Application Number **SSD-80626208**

Proposal Construction of a multi-storey residential flat building with in-fill affordable housing and Torrens Title subdivision of one lot into two (2) allotments

Location **8-10 New Mclean Street, Edgecliff**

Figure 2: SJB’s Final Envelope, incorporating the proponent’s requested amendments
Source: SJB

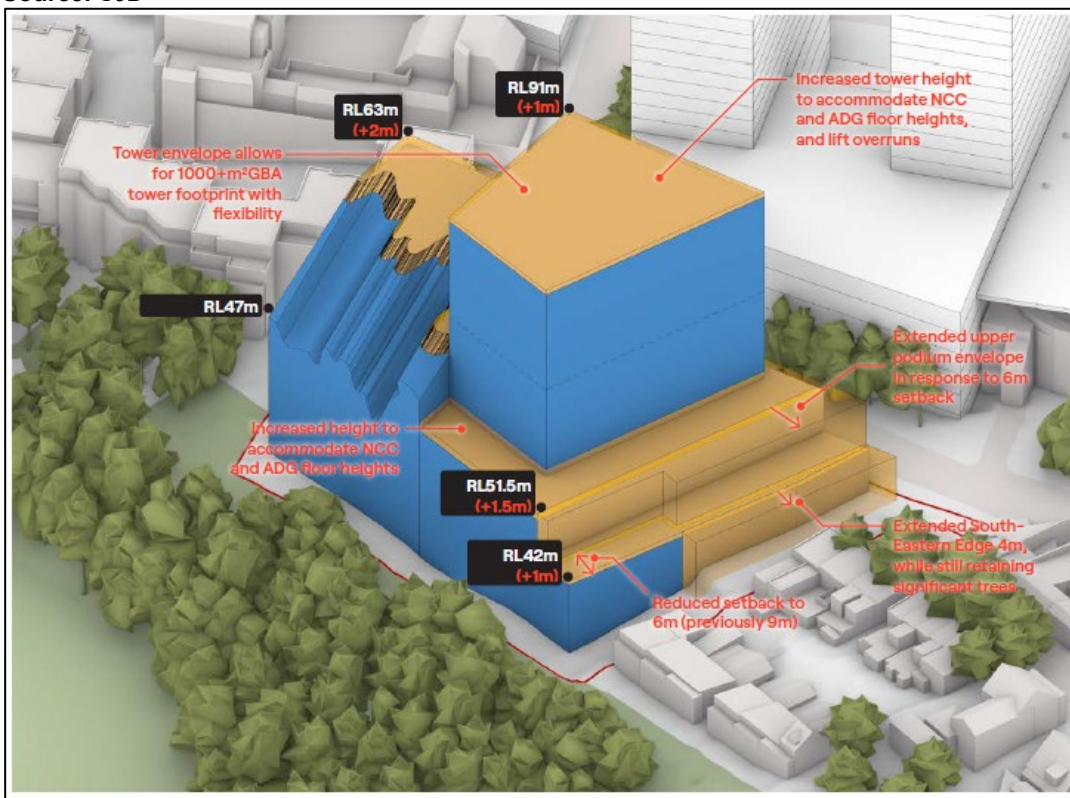
As illustrated in Figure 2 below, the endorsed RLs include an allowance of up to 2m to accommodate the National Construction Code (NCC) and Apartment Design Guide (ADG) floor-to-floor requirements, as well as lift overruns. This allowance was expressly identified as a technical provision only and was not intended to facilitate an additional storey. As stated in SJB’s independent urban design study:

Accordingly, any proposal that relies on this allowance to introduce an additional level would exceed the envelope tested and endorsed by the Panel and would undermine the integrity of the endorsed FSR for the site.

Figure 5: SSDA proposed ground floor plan with reinstated through-site link shaded in yellow.
Source: Plan FK. Annotation Council Staff

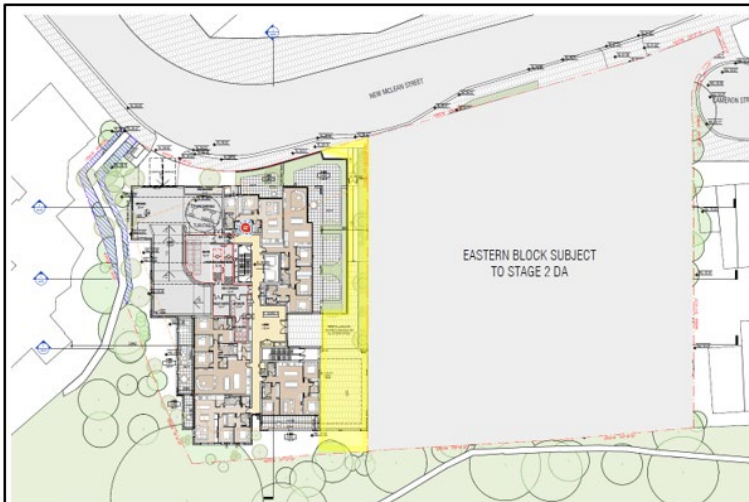
Figure 3 below depicts the originally proposed through-site link. Figure 4 depicts the concept ground floor plan with the removal of the through-site link which accompanies the current PP-2023-1648. Figure 5 depicts the current SSDA ground floor plan with the through-site link reinstated.

- Reducing the building height by at least one storey.
- Ensuring the elevation to Trumper Park does not exceed RL 47.
- Lowering and articulating the street wall to achieve a finer-grain response.
- Increasing side and rear setbacks to align with the separation and transition objectives
- Enclosing the covered 'communal open space' on the ground floor to improve the functionality of the covered communal space and remove the through-site link.

Figure 9: Deep soil landscaping shown in green
Source: Weyer and Co

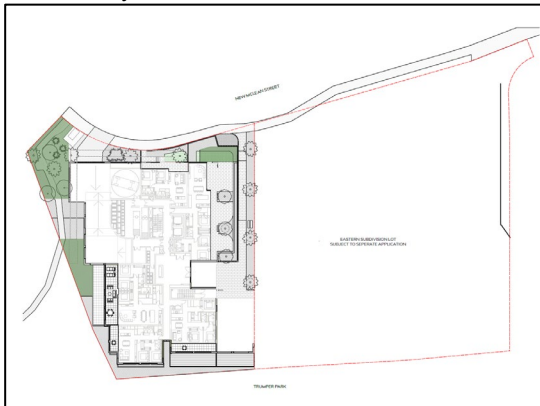
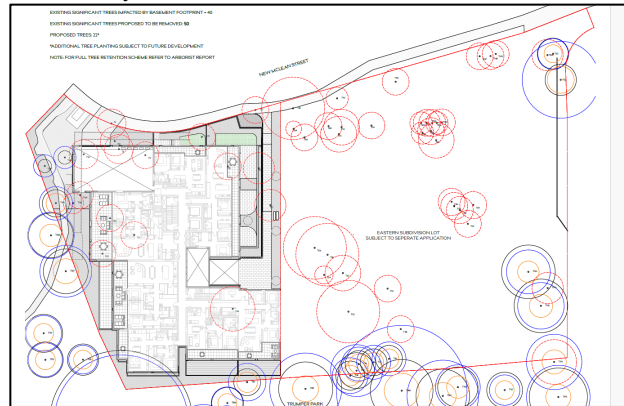
Figures 9 and 10 below depict the proposed deep soil landscaping to the western site in green and the trees proposed to be removed in dotted red.

Council staff consider the departure from the endorsed parameters contained within the site-specific draft DCP are unjustified and represent an overdevelopment of the western site.

Figure 13: Diagram showing how applying a consistent FSR to only one part of the site which is proposed to have buildings with different heights would distort where development occurs on the site. Note for simplicity this image uses different numbers to that in the proposal

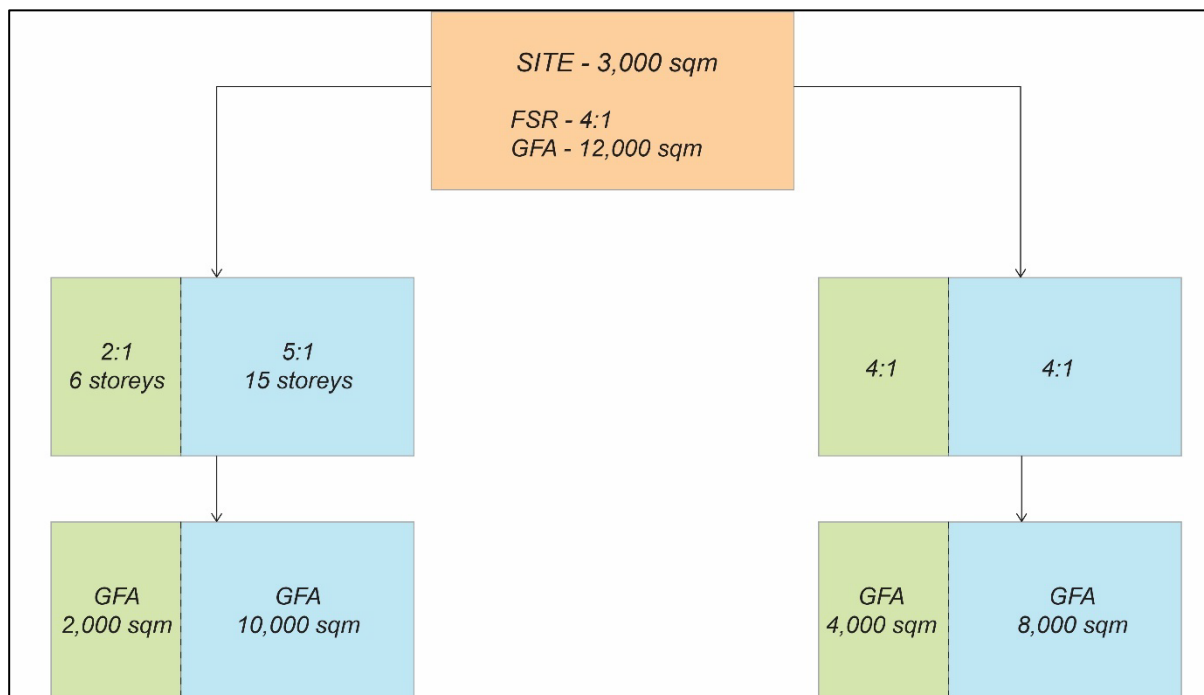
For example, while the overall maximum building height was RL91 (approximately 18 storeys) the western part of the site has a maximum building height of RL63 (assumed to be 5 to 9 storeys). This means the FSR was not assumed to be consistently applied across the site but instead was intended to be highly localised. Splitting the site into parts and applying the overall FSR to the part of the site which had been assumed to have less development would distort the proposed location of built form (see Figure 13 below).

Allocating a high FSR on the western site (Stage 1) would result in a reduced FSR allocation available for the eastern site (Stage 2). As the Stage 2 development on the eastern site is anticipated to achieve the recommended 18-storey height limit, the redistribution of FSR toward the western side in Stage 1 will either require an increase in the overall site FSR to accommodate the intended built form outcomes in Stage 2, or a reduction in the quantum of development possible in Stage 2. The proposal should therefore reconcile this discrepancy and clearly demonstrate how the cumulative FSR and desired built form across both stages will remain within the 3.7:1 limit established by the Gateway Determination for the site.

- Typically a 10-storey residential flat building can reasonably be achieved at an FSR of approximately 3.1:1. The current proposal of 3.42:1 on the western site locates a disproportionate share of the total site FSR on this part of the site, which is creating poor design outcomes including a deep floorplate building, apartments with little or no sunshine and limited side and rear setbacks.
- It is recommended that the FSR of the western site be reduced to ensure it complies with the built form supported in the planning proposal.

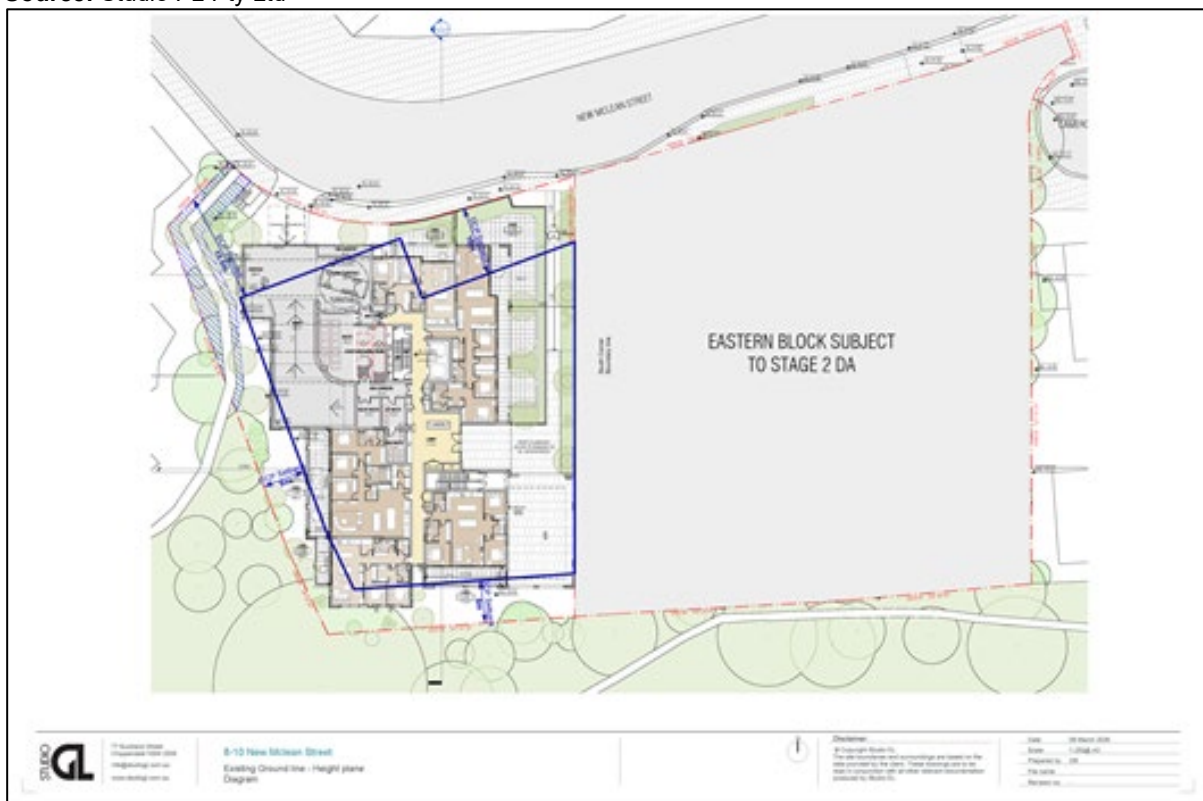
The amended LEP height map identifies a maximum building height of RL63m. The site-specific draft DCP and the SJB study recommended building envelope proposed that this maximum height only occur along New McLean Street, falling to RL47.6m from the rear of the western site to avoid overshadowing Trumper Oval. The proposed building, while [stated to be] within RL63 is not fully within the recommended building envelope. The proposed lift overrun and the swimming pool deck at Level 5 both breach the DCP building envelope, with the lift overrun exceeding the envelope by approximately 2.35m. These breaches increase the bulk and scale of the building form and result in overshadowing to Trumper Oval to the rear of the site.

living, dining and kitchen areas. It is recommended that the depth of these apartments and balconies is reduced.

- Reduce the depth of single aspect apartments so that the maximum depth of open plan living, dining and kitchen areas does not exceed 8m.
- Revise the FSR calculations to include all enclosed communal amenity spaces at Ground and Level 5 to ensure an accurate GFA assessment.
- Remove secondary balconies given that primary balconies already provide adequate outdoor amenity.

Figure 16: Extract from EIS showing the difference between the draft DCP setbacks (in orange) and the proposed development (black line). This diagrams also identifies proposed side and rear setbacks.

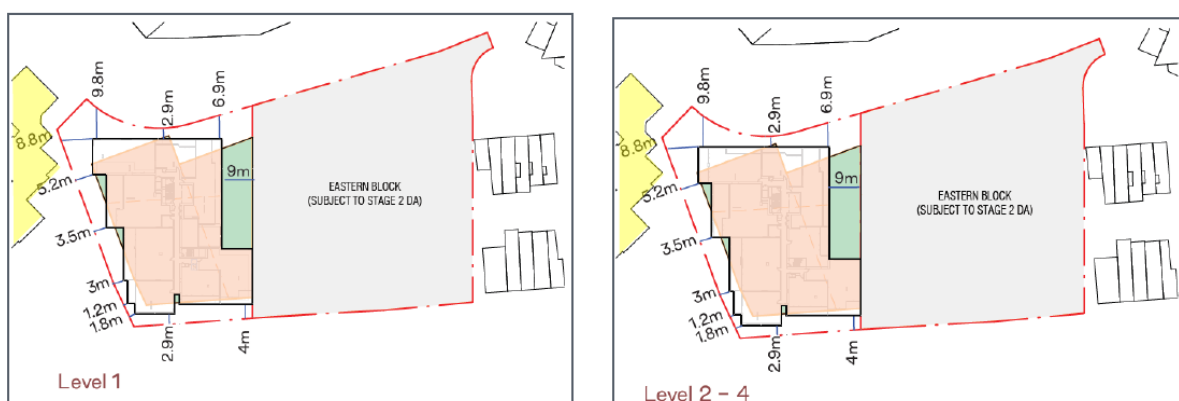
The proposed front setback is predominantly narrow (down to 2.9m) and the 'front' of the building consists of a driveway and fire booster assembly, fenced private open spaces that do not address the street and gated side access. This contributes little to

- Provide setbacks that are consistent with the ADG and increase the opportunity for access, maintenance and landscaping along the side and rear boundary.
- Setbacks to the rear and western side should provide sufficient space for screening landscape and limit overshadowing of Trumper Oval.

Figure 19: Extract from Tree Canopy Area (adjacent to loading dock)
Source: Wyer and Co

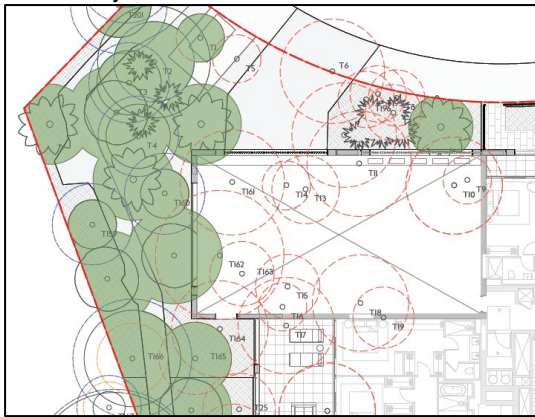
- The proposed tree canopy adjacent to the western side of the loading dock, which encroaches over the proposed building footprint is included in the calculations. In this section the building is 10 storeys high, so it is unfeasible for the tree canopy to overhang the building. Refer to Figure 19 below.

Figure 20: Extract from Tree Canopy Area (Tree T107)
Source: Wyer and Co

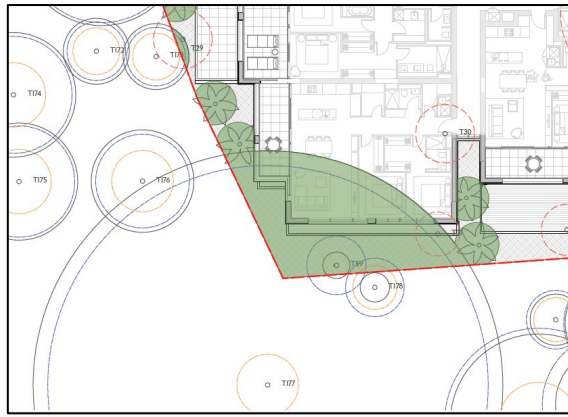
- The tree canopy calculations include the section of tree canopy of T107, which overhangs the site from its location within Trumper Park. As identified above, the proposal would necessitate the removal of this section of the canopy to accommodate the building. It is therefore inappropriate to include canopy which will be removed due to the provision of the 5-storey building in this location. Refer to Figure 20 below.

Figure 21: Basement 04 Plan with space around supporting columns highlighted in red.
Source: Plan FK. Annotations Council Staff

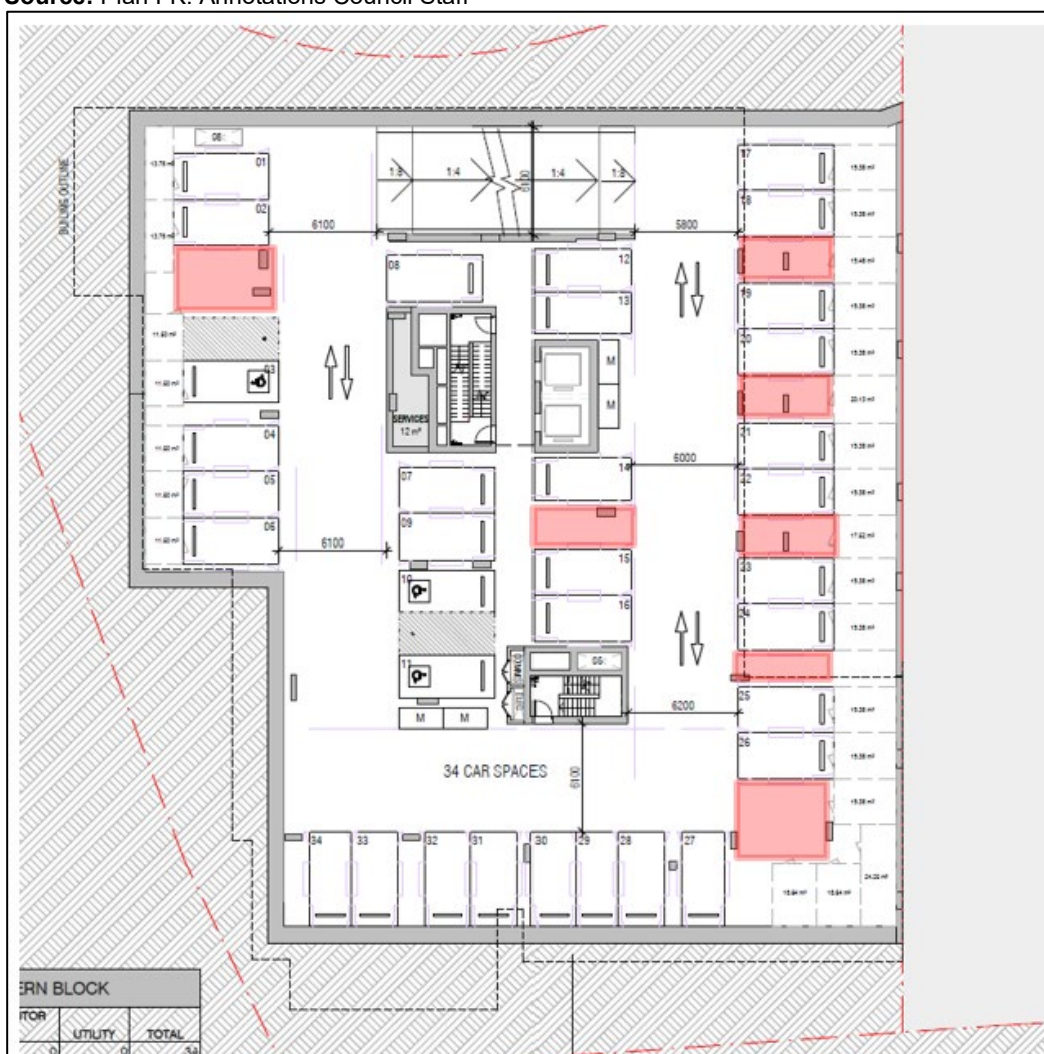
Council's planning staff also question the efficiency of the car park design. At basement levels 02, 03, 04, and 05, the proposal appears to provide excessive space around the supporting columns in the basement (refer to Figure 21 below). A more efficient design would enable a reduction to the excavation and increased setbacks for deep soil landscaping.

Figure 22: Basement 02 Plan with 6 x utility spaces highlighted in red.
Source: Plan FK. Annotations Council Staff

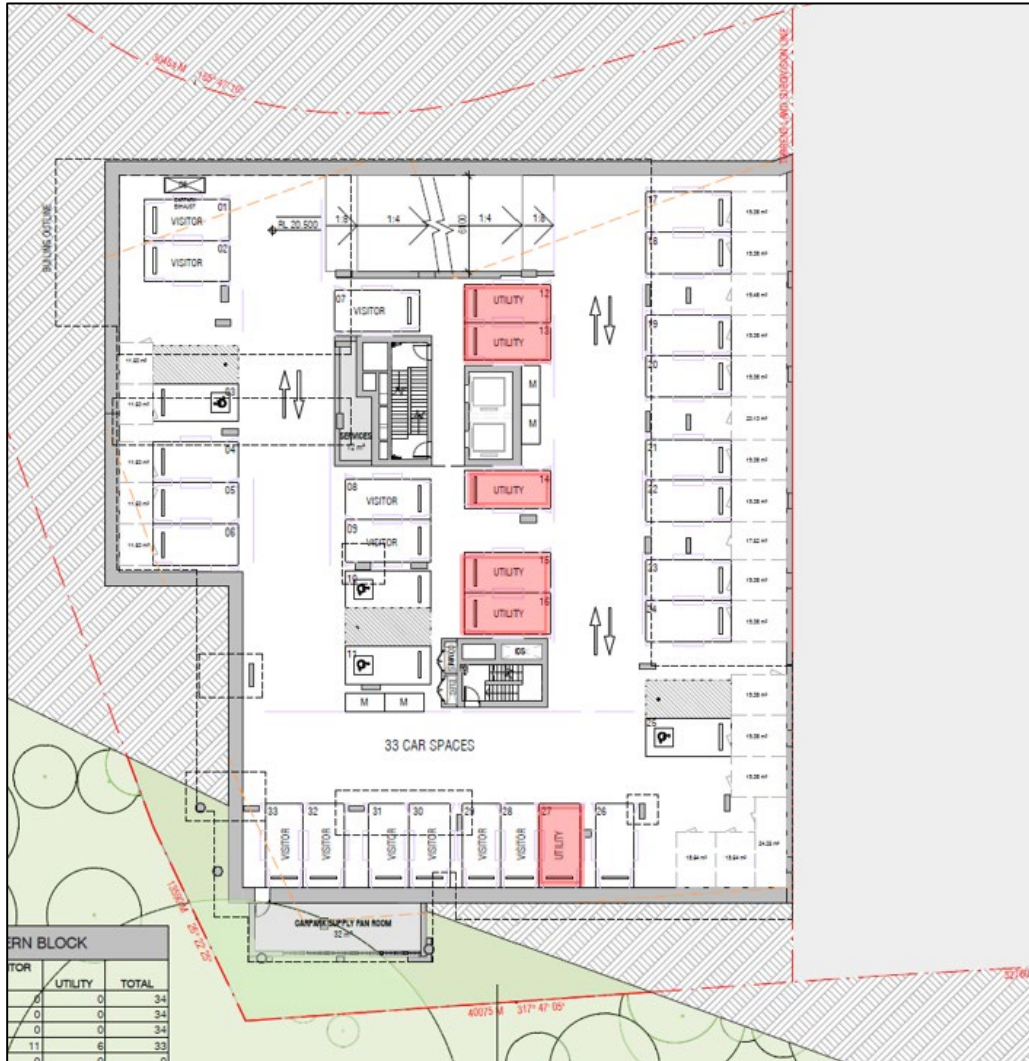
The car parking provision referenced in the Transport Impact Assessment and the EIS are inaccurate and do not reflect the car parking provision shown on the architectural drawings. Both documents identify that the proposal provides 134 car parking spaces (118 residential and 16 visitor spaces). However, the architectural drawings show 140 spaces (34 spaces at level B05, 34 spaces at level B04, 34 spaces at level B03, 33 spaces at level B02, and 5 spaces on the lower ground floor).

The difference in total car parking spaces can be attributed to the 6 x 'Utility' car parking spaces provided at level B02 (refer to figure 22 below). There is no reference or assessment of these utility spaces within the Transport Impact Assessment or the EIS. These spaces should be deleted.

Figure 24: Annotated ground floor plan
Source: Floor plan FK. Annotations Council staff

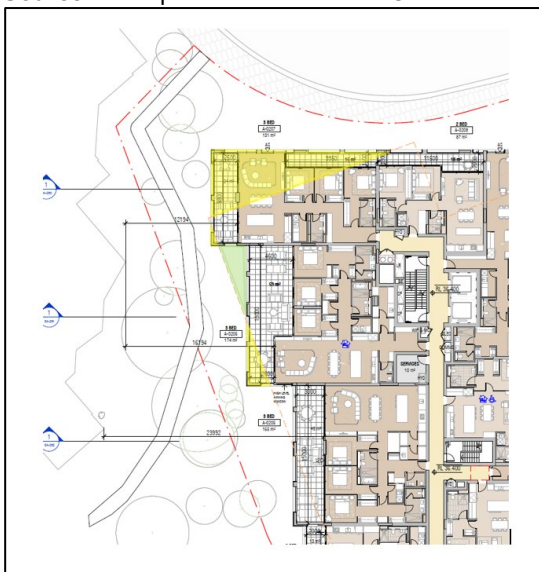
Figure 24 below depicts the building footprint permitted under the site-specific draft DCP in a dashed orange line. The proposed exceedances of the building footprint, at the northern corner of the site adjacent to the public footway, are depicted in yellow, and reduction to the building footprint is shown in green.

The breaches of the building footprint and the location of the substation and vehicular access adjacent to the public footway entry would have a detrimental impact of the amenity of the public footway in terms of sense of enclosure, visual amenity, and pedestrian safety.

Figure 25: Extract level 2 floor plan
Source: FK

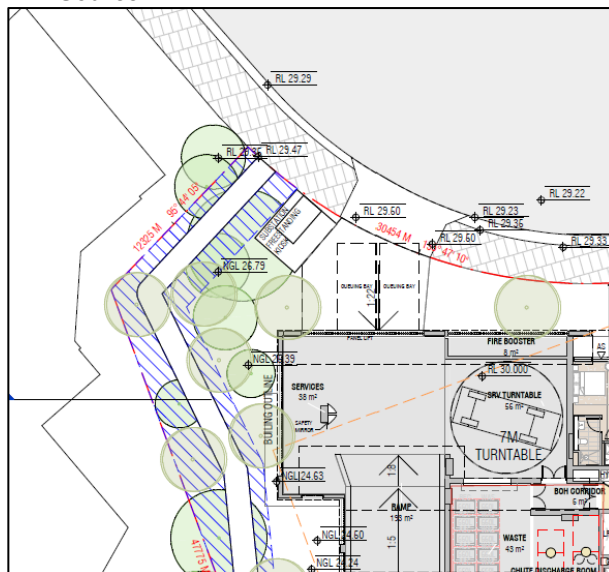
Figure 25 below details the proximity of the public footway to the proposed substation and the proposed vehicular access to the site. Noting that the provision of a freestanding substation and locating the vehicular access to the northern corner of the site are contrary to the requirements of the site-specific draft DCP (refer to section 13).
